Interactive comment on “The effect of water storage change in ET estimation in humid catchments based on Budyko framework and water balance models” by Tingting Wang et al.

Tingting Wang et al.

Fig. 1. Figure 5 The box plot of R^2 between monthly ETwb and ETbudyko using the extended Budyko equation, i.e., $P-\Delta S$ as equivalent P , and ΔS is obtained from abcd model.

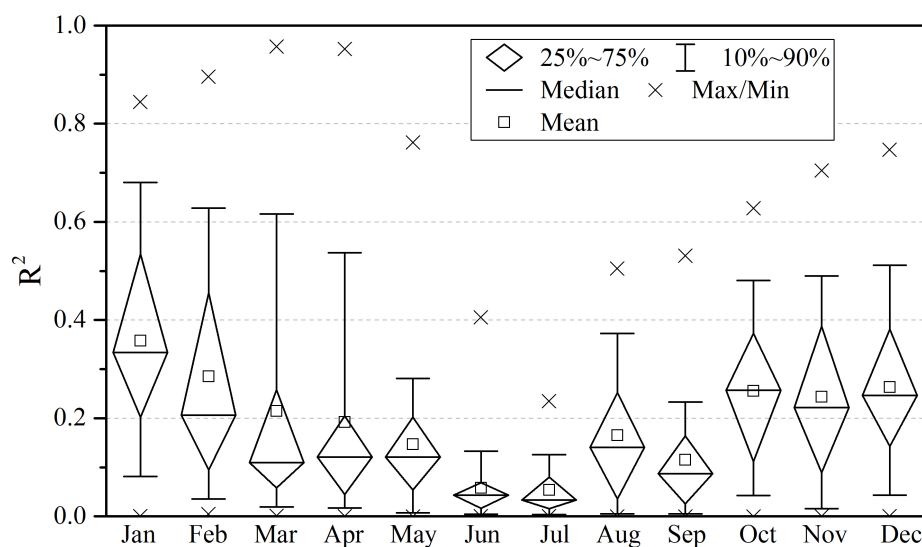
The writing of this paper needs a lot of improvement, and can benefit strongly from a native speaker rigorously rewriting it. I made a long list of suggestions for the first 50 sentences, but this list is not exhaustive (even not for this small part of the manuscript). In its current stage I cannot fully judge the scientific merit of the contribution because the I do not always understand the interpretation of generated results. The paper does not address anything sufficiently novel. The main conclusion that water storage changes can be significant at annual time-scales is already well known. In addition, some of the methods that the paper uses to estimate ET (Budyko and a water balance

accounting) have been extensively reported to be only applicable at longer time-scales. Consequently, I do not see why the paper is relevant to HESS. The manuscript is not based on sound reasoning that can be easily followed. While this may be a linguistic issue, since the authors are (I assume) no native English speakers, it hinders me from properly judging the scientific merit of this work.

a) We have added the result about the effect of ΔS on annual ET estimation based on Budyko framework in section 3.3. It shows that almost no improvement has been made in annual ET estimation based on the extended Budyko equation (Figure 6), which uses $P - \Delta S$ as ‘equivalent’ precipitation at monthly timescale through high R^2 achieved (Figures 5 and 6), which is due to the seasonal pattern within the year.
